BOURN AIRFIELD – OUTLINE PLANNING APPLICATION CONSULTATION RESPONSE

1.10 The planning application reference number is S/3440/18/OL.

APPENDIX 1: OFFICER RESPONSE TO OUTLINE PLANNING APPLICATION FOR BOURN AIRFIELD

S/3440/18/OL

1.9 Diagram 2 below shows the illustrative masterplan for the development proposals.

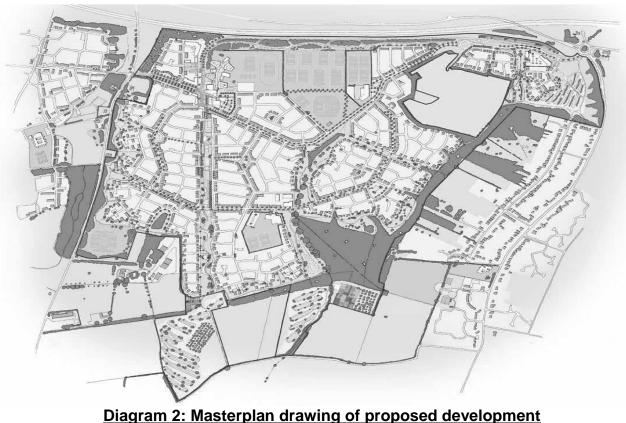
- 1.10 A 3 FE primary school requires a site of 3 hectares and a 4 FE primary school a site area of 4 hectares. The proposed master plan will need to be reviewed in this respect.

- The County Council supports the provision of well-established green routes throughout the development. The County Council recommends that the most strategic routes be recorded as Public Rights of Way with the expectation that other connecting routes within the site would remain privately maintainable. This approach has been successfully implemented in Cambourne and at Northstowe. The Masterplan for Cambourne included the provision of new public rights of way which are almost complete. This was an important blueprint and the County Council requests that the Bourn Masterplan be amended to include PROW along the lines suggested.

- It is noted that the Masterplan indicates several green routes around the perimeter of the site. There should be an aspiration for establishing a circular perimeter route of Bridleway status around the development. This infrastructure is proving to be highly successful in other large scale developments in Cambridgeshire such as Cambourne
